ADDENDUM NO. 2

23 January 2017

RE: MILLER PARK DISTRICT PHASE 1
Contract no. R-14-011-201

FROM: Spackman Mossop Michaels / Eskew+Dumez+Ripple, Joint Venture
365 Canal Street, Suite 3150
New Orleans, Louisiana 70130
(504) 561-8686

STEP LAYOUT PLAN

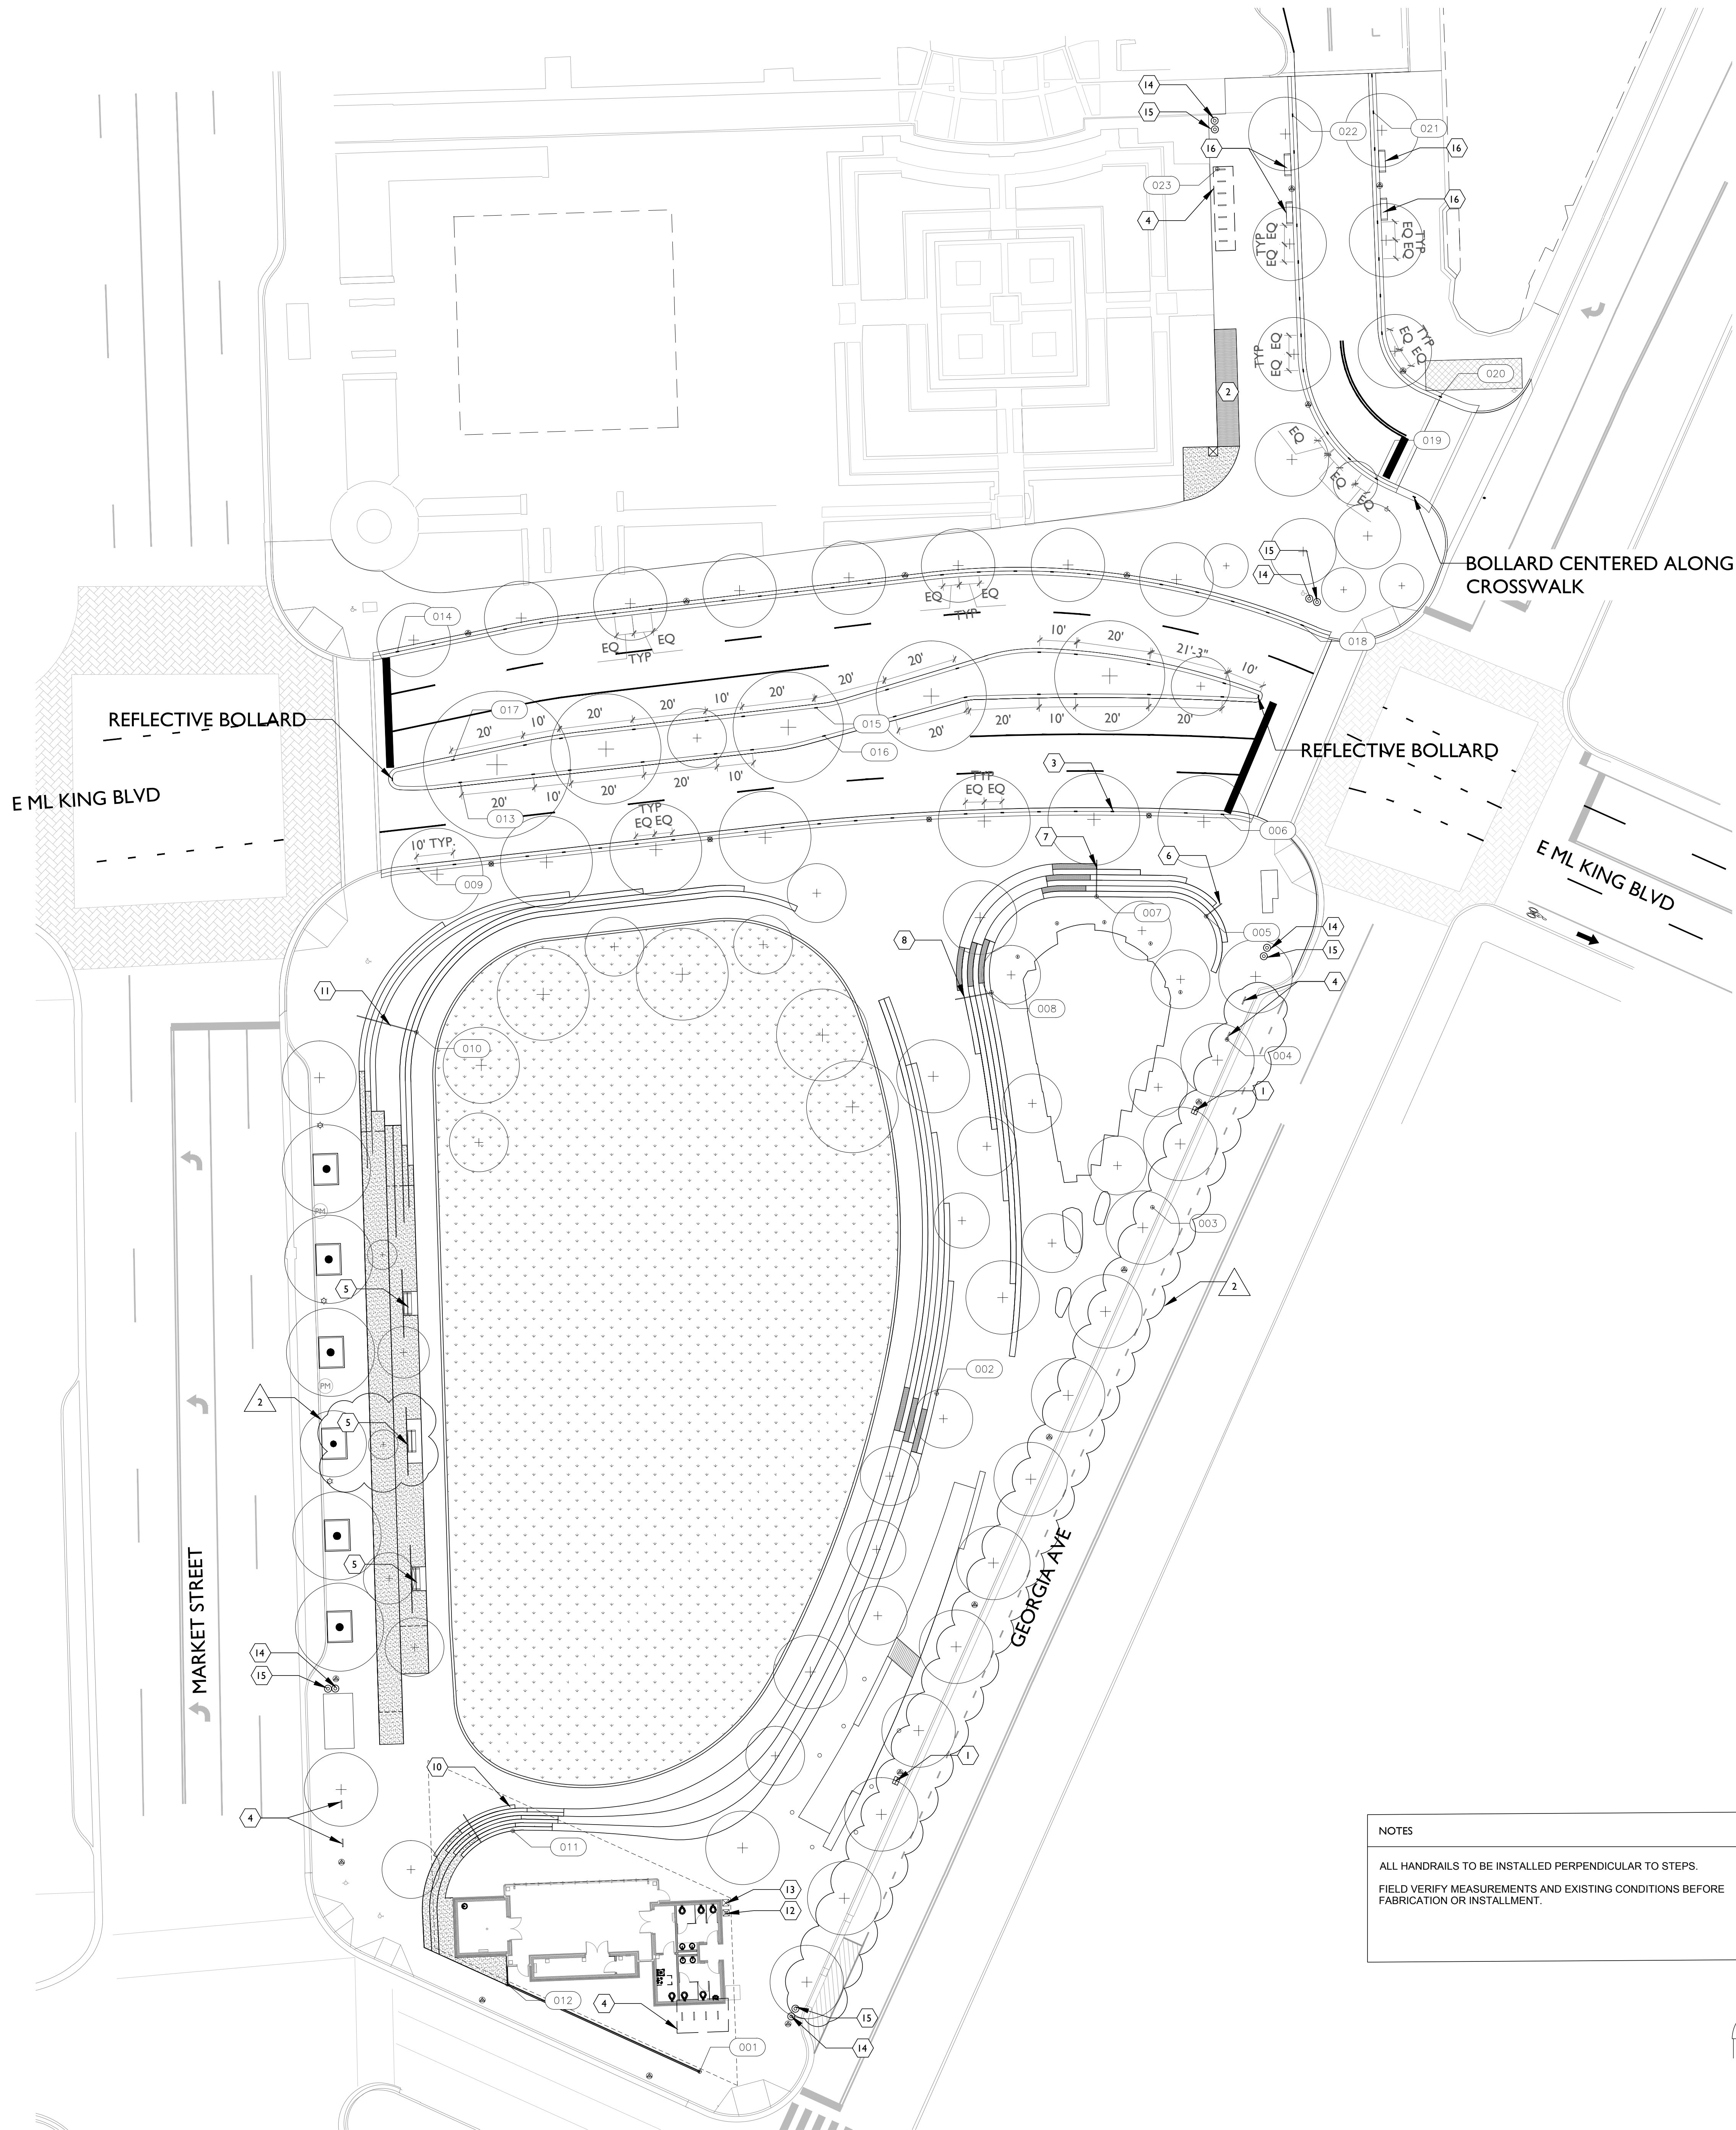
- K. L1.2- STEP LAYOUT PLAN: Removed parking space striping on all LA plans along Georgia Ave. Please see C103 for Roadway and Striping Plan.
- L. L1.6- SITE FURNISHINGS PLAN: Adjusted bench locations along garden terrace. Removed parking space striping on all LA plans along Georgia Ave. Please see C103 for Roadway and Striping Plan.

1 SITE LIGHTING LAYOUT PLAN
L1.7 1" = 20'-0"

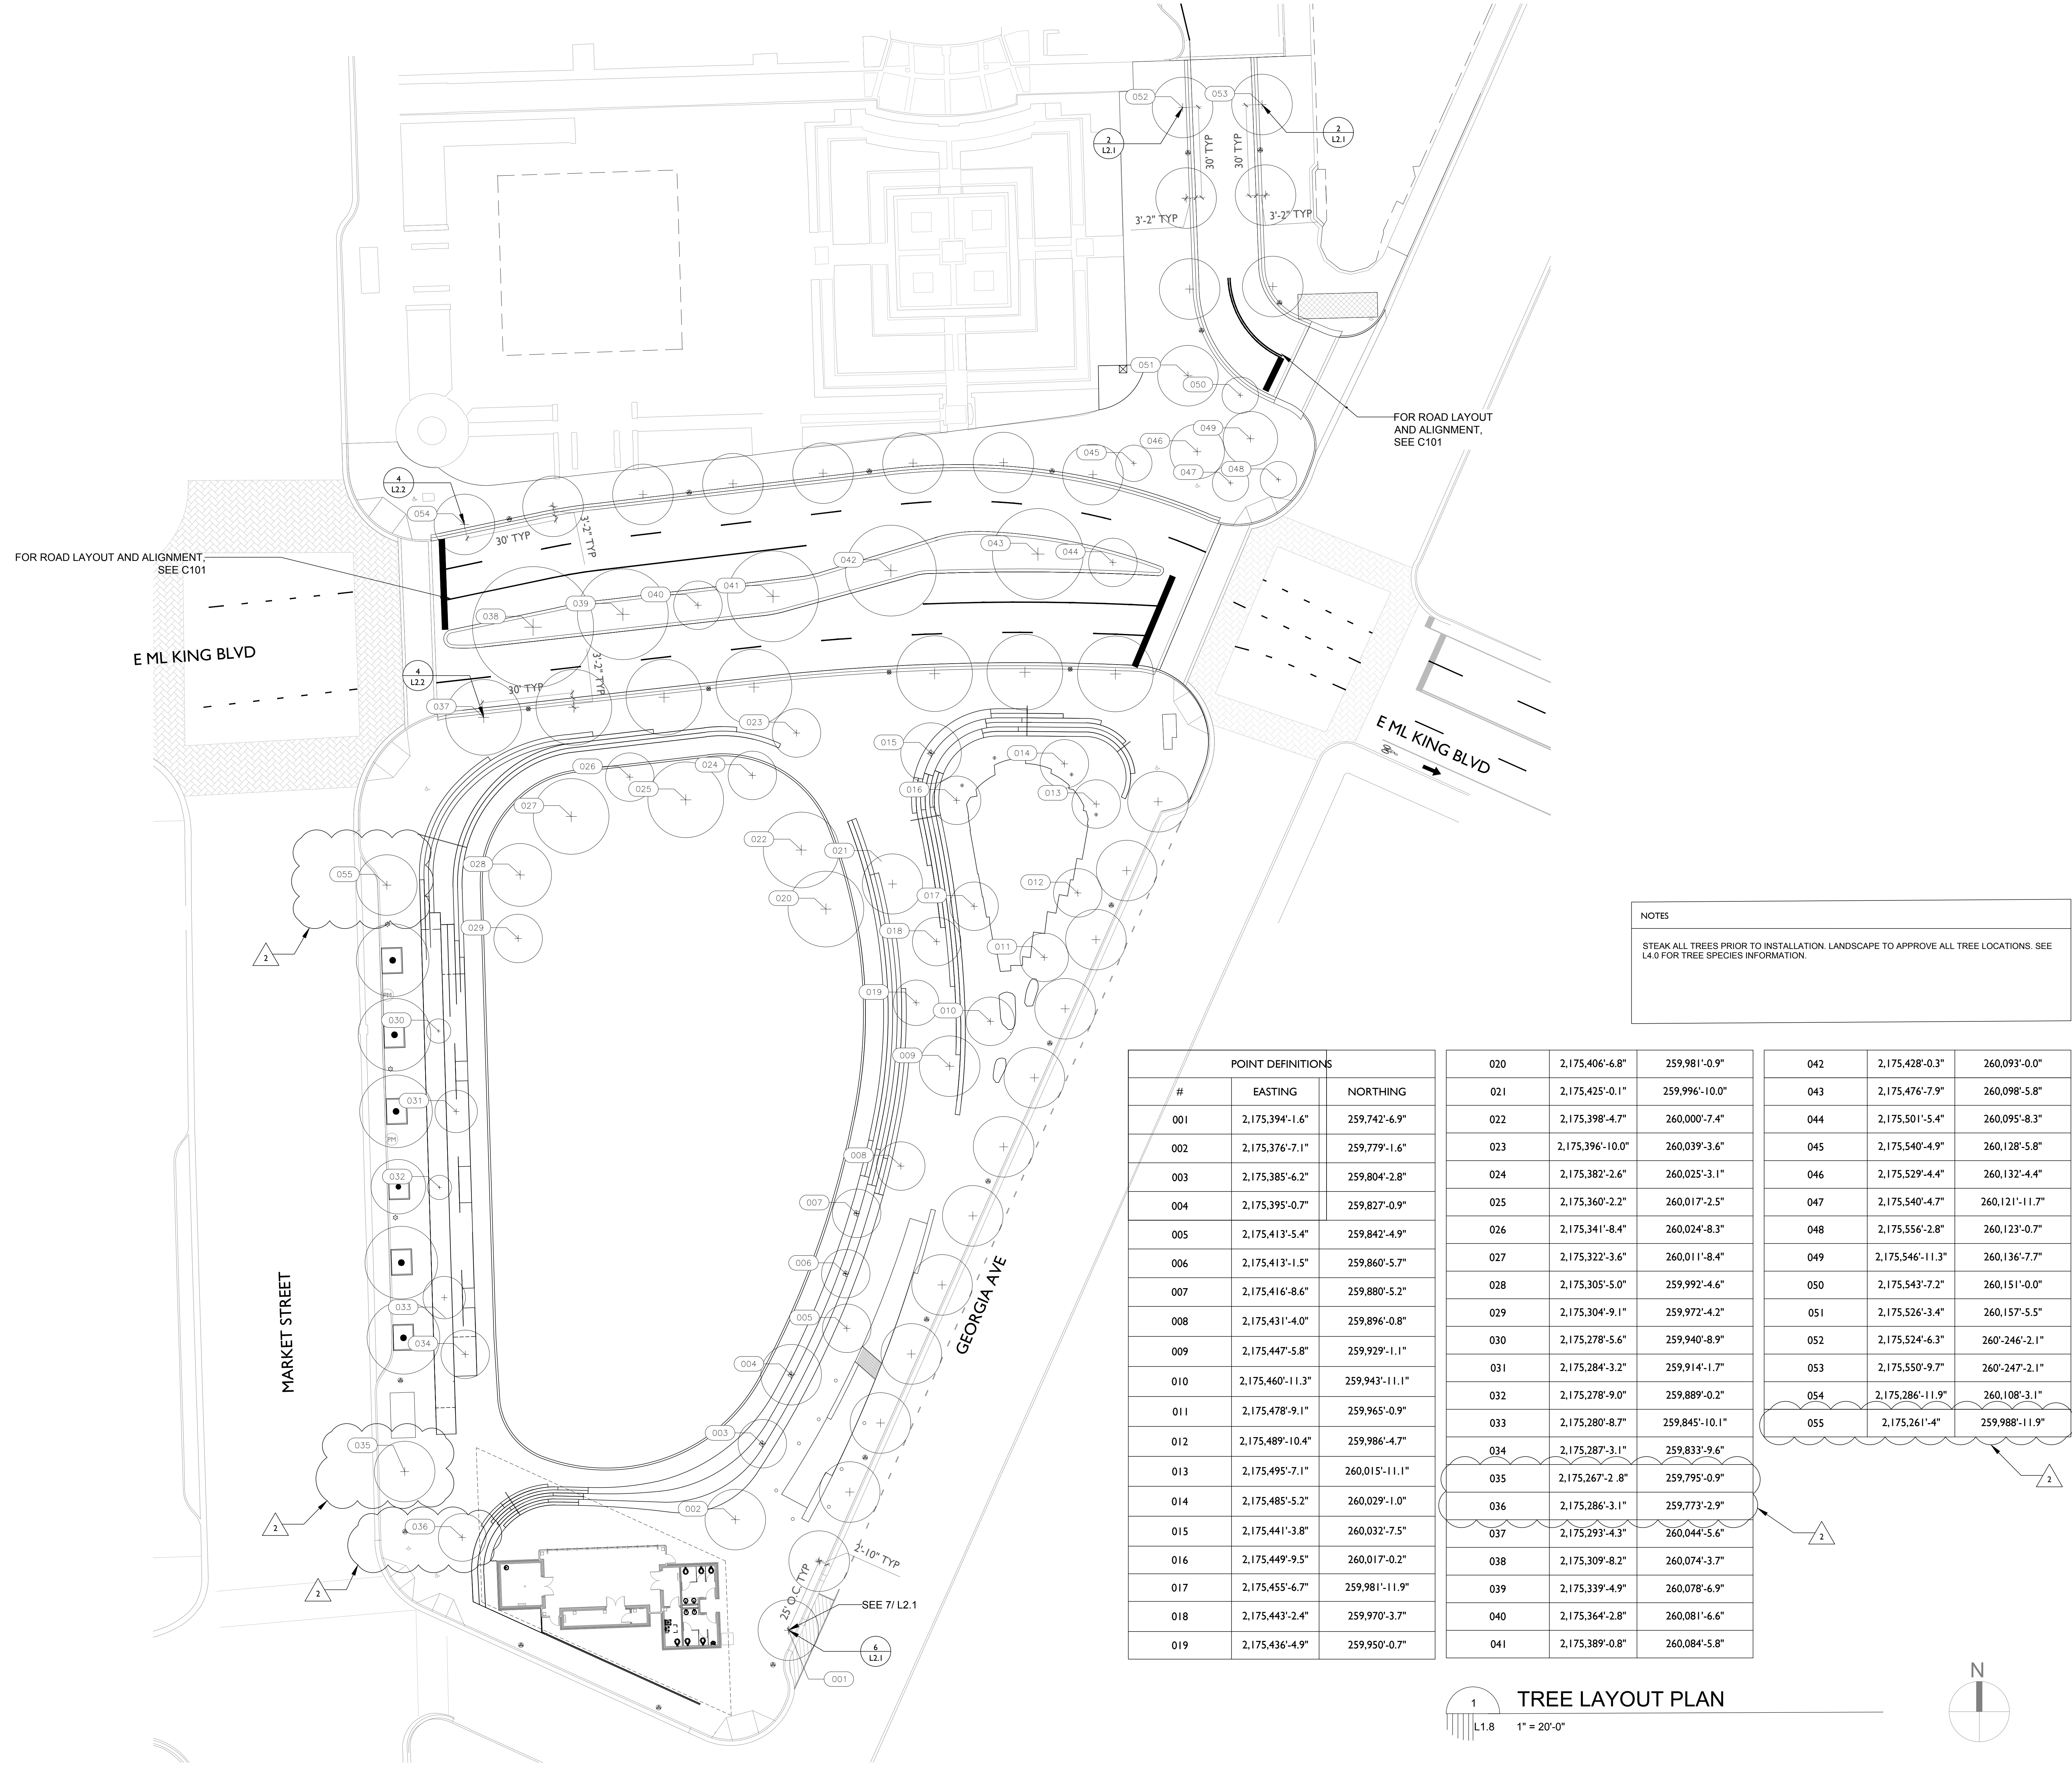
- M. L1.7- SITE LIGHTING LAYOUT PLAN: Adjusted light poles on SE corner of Market St. and updated point definitions. Adjusted linear lights along garden wall. Removed parking space striping on all LA plans along Georgia Ave. Please see C103 for Roadway and Striping Plan.

1
L1.8
1" = 20'-0"

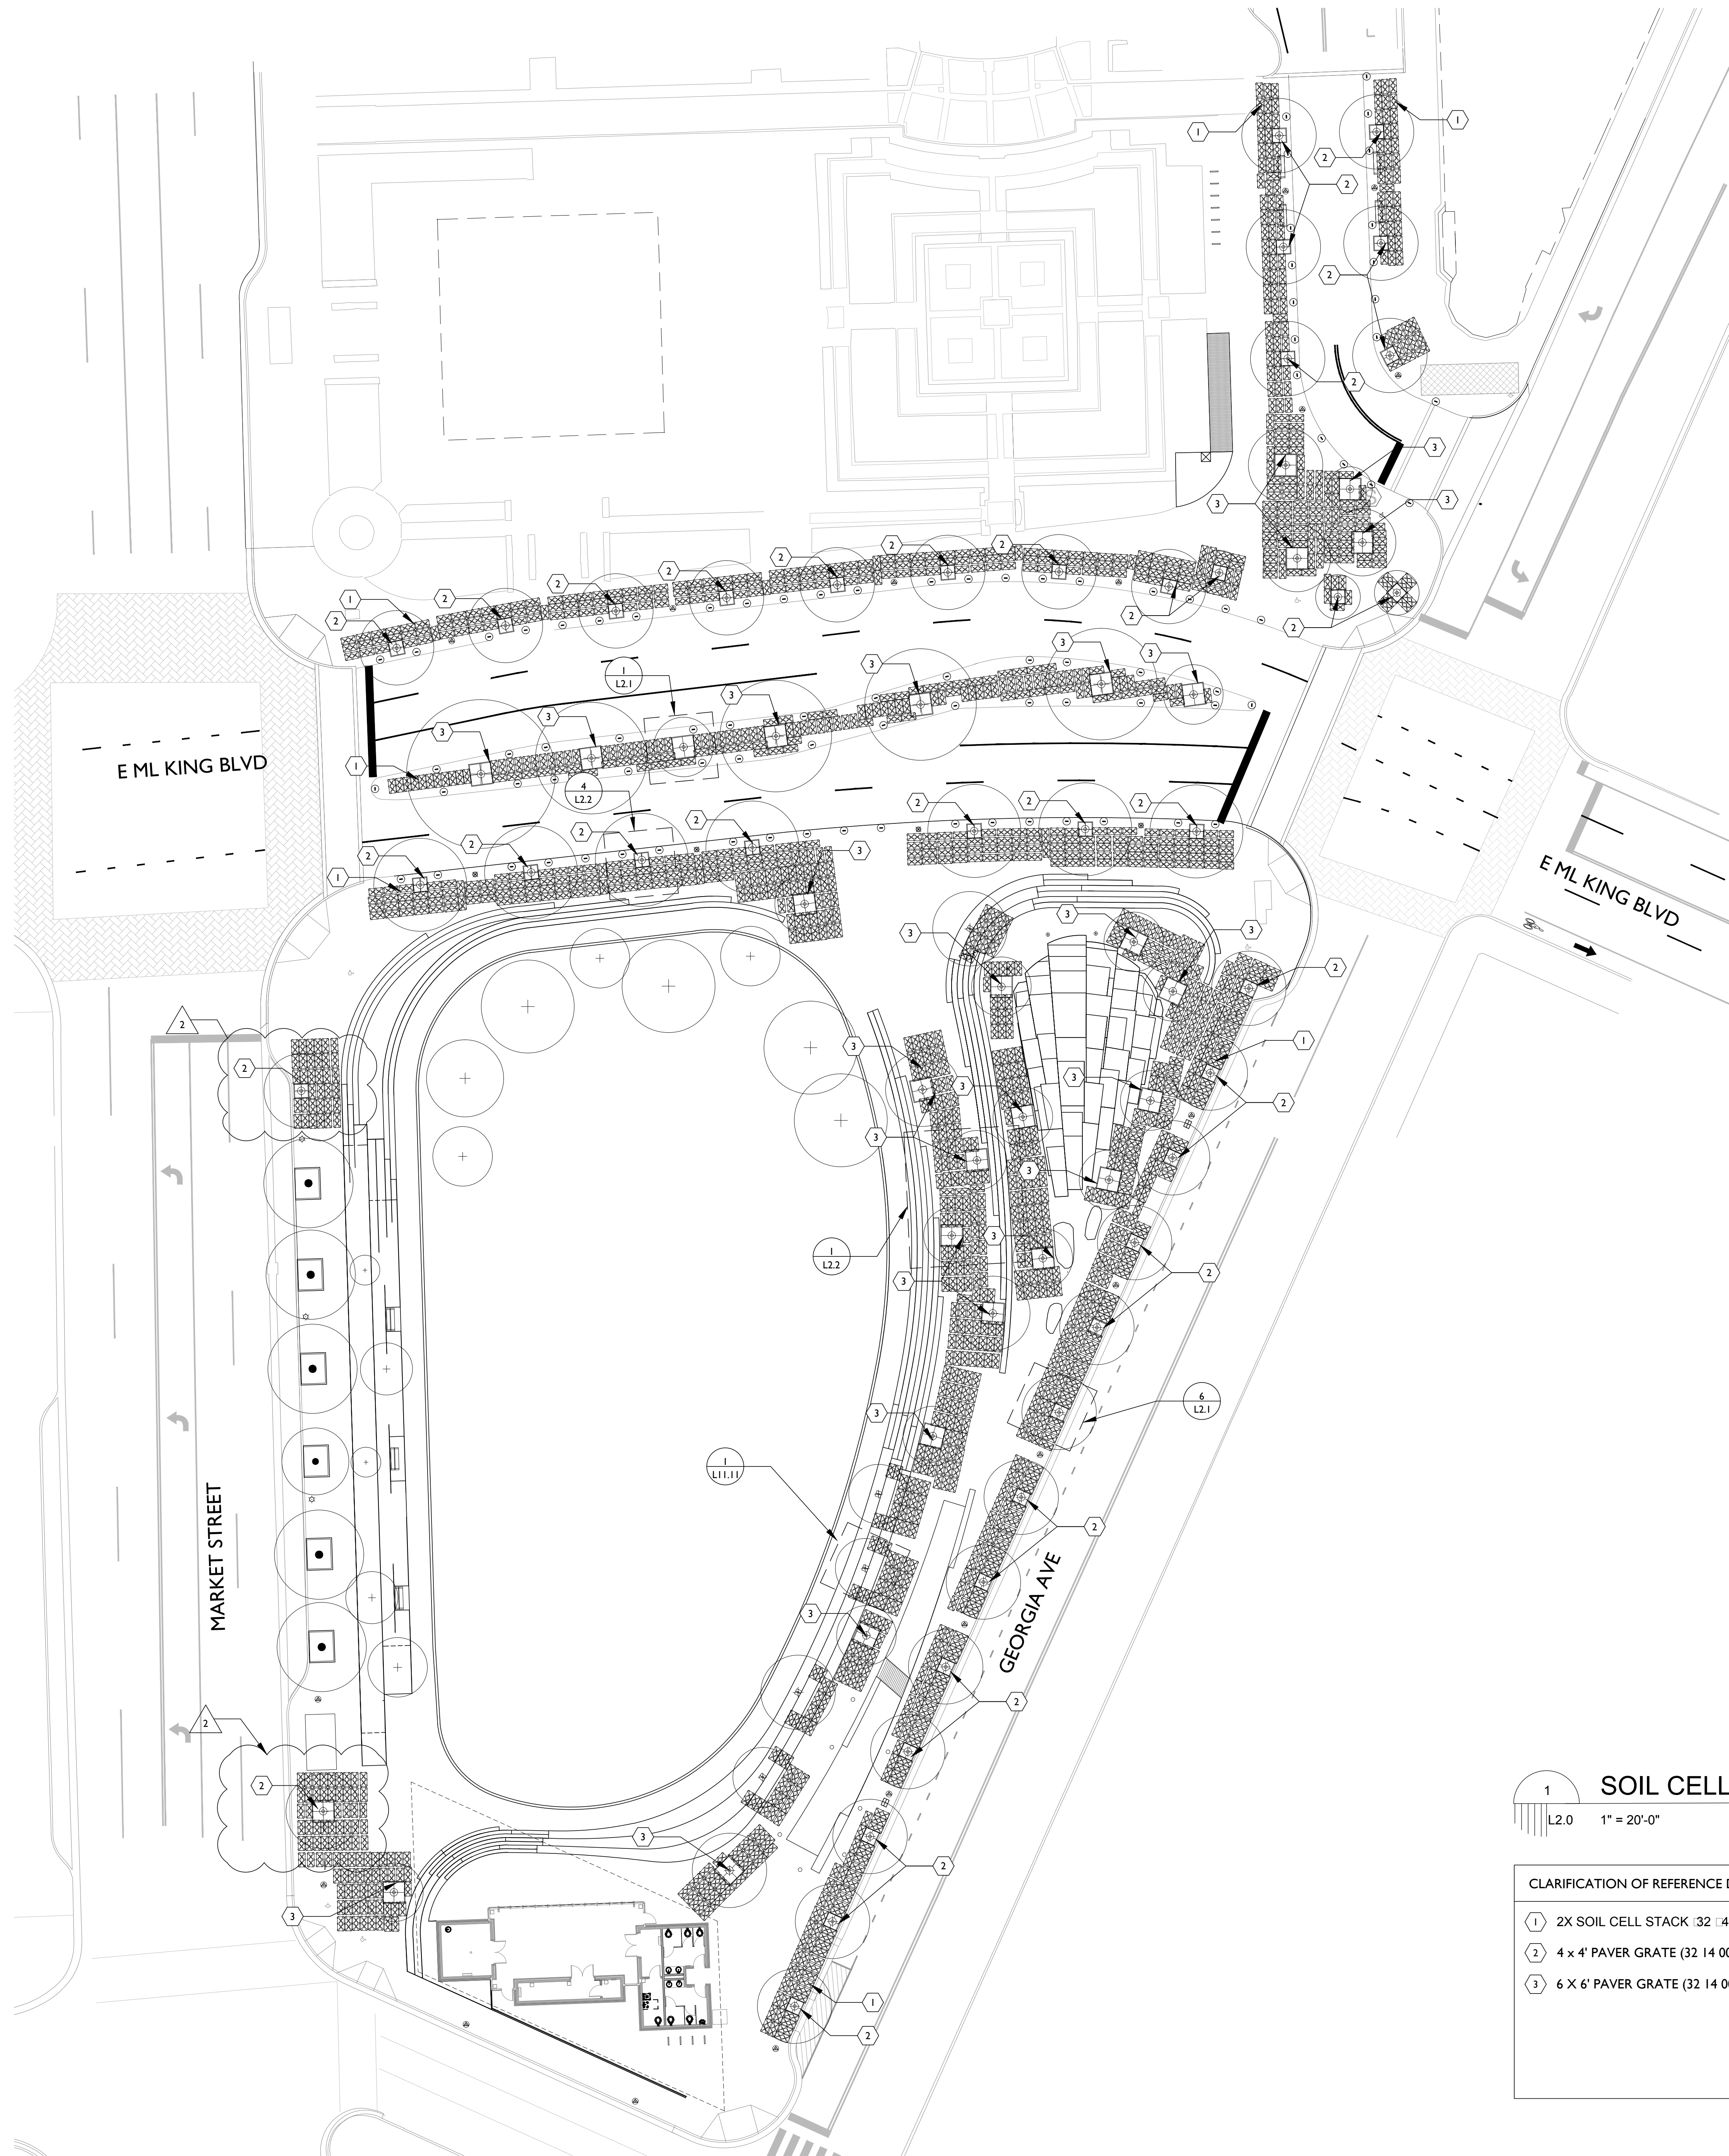
- N. L1.8- TREE LAYOUT PLAN: Updated tree locations and point definitions.
- O. L2.0- SOIL CELL PLAN: Updated Paver Grate sizes along Market St. and soil cell arrangement around these trees.
